NOTICE OF VIOLATION

On June 18, 2024, Energy Safety conducted an inspection of SCE's WMP initiatives in the vicinity of the city of Trabuco Canyon, California. The inspection report is enclosed herewith. Energy Safety found the following violation(s):

INSPECTION REPORT

Item2GImg2: Overall Pole

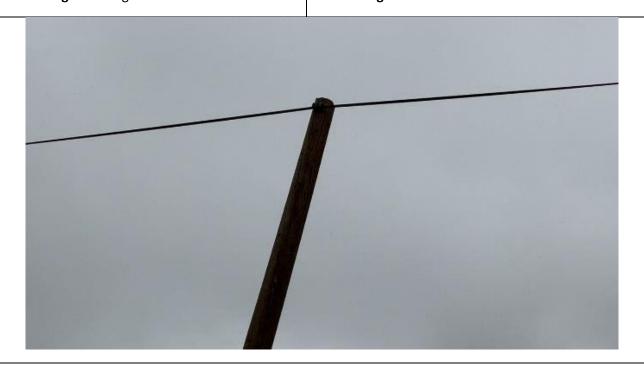
On pole ID X8485E at 32187-32197 Trabuco Creek Rd, Trabuco Canyon, CA, 92679, USA, 33.66801439418881, - 117.56562608196106, the inspector observed that no covered conductor was present. The inspector's observation is documented in Violation 2 photographs, which are attachments to this report. Photo numbers Item2IG1Img1, Item2IG1Img2 and Item2IA1Img1 depict that no covered conductor was installed at the location.

- 1. Southern California Edison Company's 2023 WMP Covered Conductor (8.1.2.1.1) work was identified as complete at this location.
- 2. Covered Conductor (8.1.2.1.1) was not installed.
- 3. Only communication cable was present on the pole.
